## Fire Safety Statement (Inc. Evacuation Strategy)

**PROJECT NAME:** Brunswick Centre, Bloomsbury

**REF:** OF-000957-OFS-01-C

**Orion Fire Drawing Review - RIBA 2**

**Figure 4: Reduced Escape Width - Existing Columns**

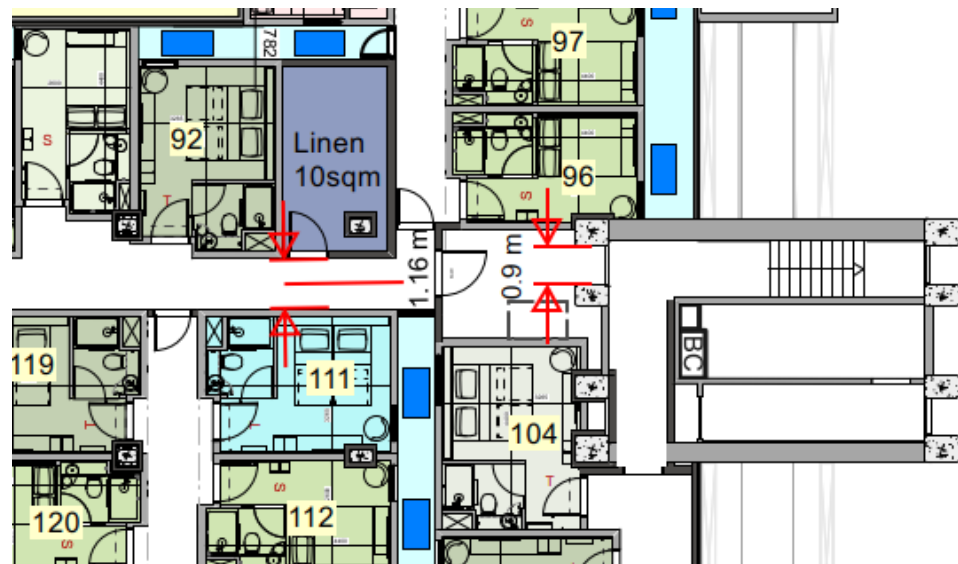
- 4.3.6 It has been advised by the Architect that there is reduction in width along the escape route leading to the stair located on the right-hand side of the plan (which discharges to the shopping centre central street at ground floor level) due to the presence of existing columns (see Figure 4). The columns reduce the escape width to 900mm, a reduction of approximately 216mm from the bedroom corridors, before returning to 1800mm once in the stair at leading to ground floor. Although for compliance with Building Regulations the escape route should not narrow at any point to the storey exit, it is considered the due to the number and width of exits available exceeding those required for the number of occupants proposed (442 persons) the situation can be considered acceptable. In addition, in line with Table 7 above, a 900mm width is able to support 110 persons and therefore it is not considered that this reduction in width will have a negative impact on the exit capacity. The hotel will be provided with a Category L1 system throughout (BS 5839-1), which will provide early warning to occupants. This coupled with an AWFSS to limit the fire spread in the early stages will provide occupants with a greater time to make their escape. This is variation from guidance and is subject to acceptance and agreement with Building Control.

Drawing  
**PROPOSED GA PLAN B2**  
 Lower basement

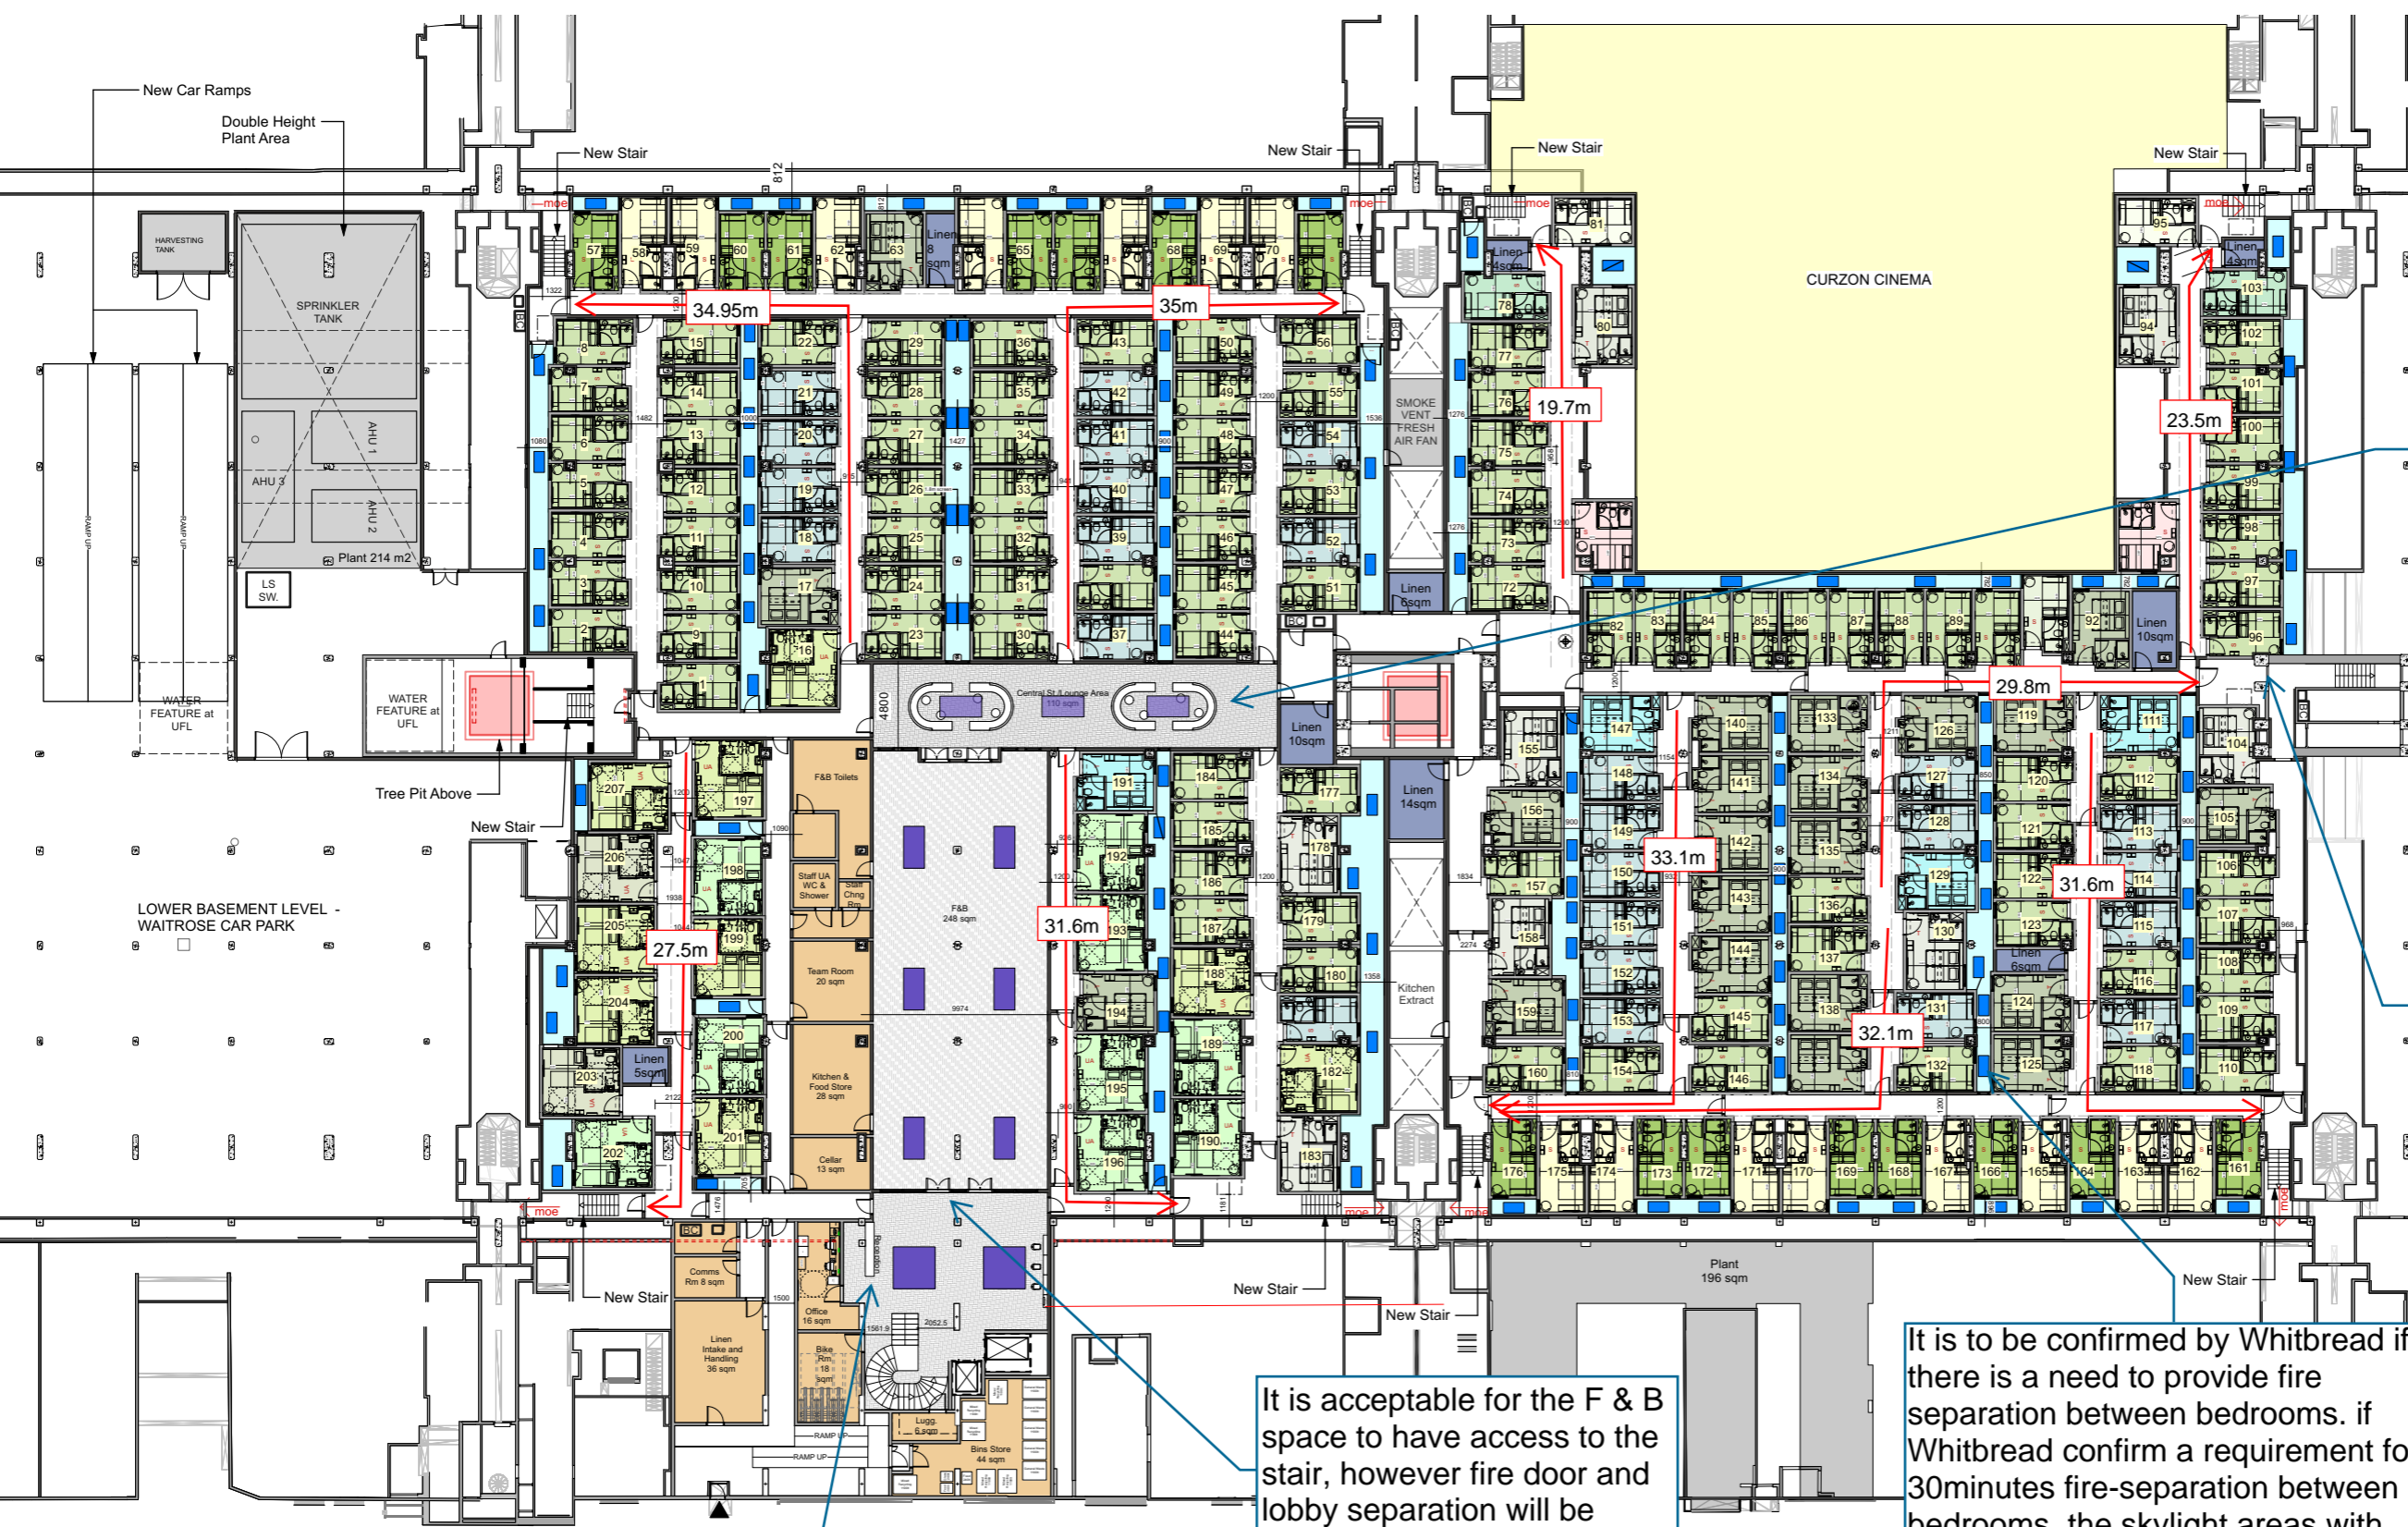
Occupants of the bedrooms are required to make escape through the central street which will contain furniture and is proposed to be a lounge area. For this reason the central street is not a protected escape route, however, a justification for this based on clear width of escape routes and limited fire load etc. will be provided as part of the RIBA Stage 3 report. This is however a variation from guidance and so will be an approvals risk.

Noted that there is reduction in the escape width here from 1160mm in the corridor to 900mm between columns. A justification has detailed in the report, however, this is a variation from guidance and therefore an approvals risk. This is also an operator risk, to be agreed alongside Building Regulations.

It is to be confirmed by Whitbread if there is a need to provide fire separation between bedrooms. if Whitbread confirm a requirement for 30minutes fire-separation between bedrooms, the skylight areas with opening windows to bedrooms will be a breach of that requirement. In addition, FR glazing will be required and all windows to be fixed shut.

It is acceptable for the F & B space to have access to the stair, however fire door and lobby separation will be required.

Reception area exceeds 10m<sup>2</sup>. A justification has detailed in the report, however, this is a variation from guidance and therefore an approvals risk.
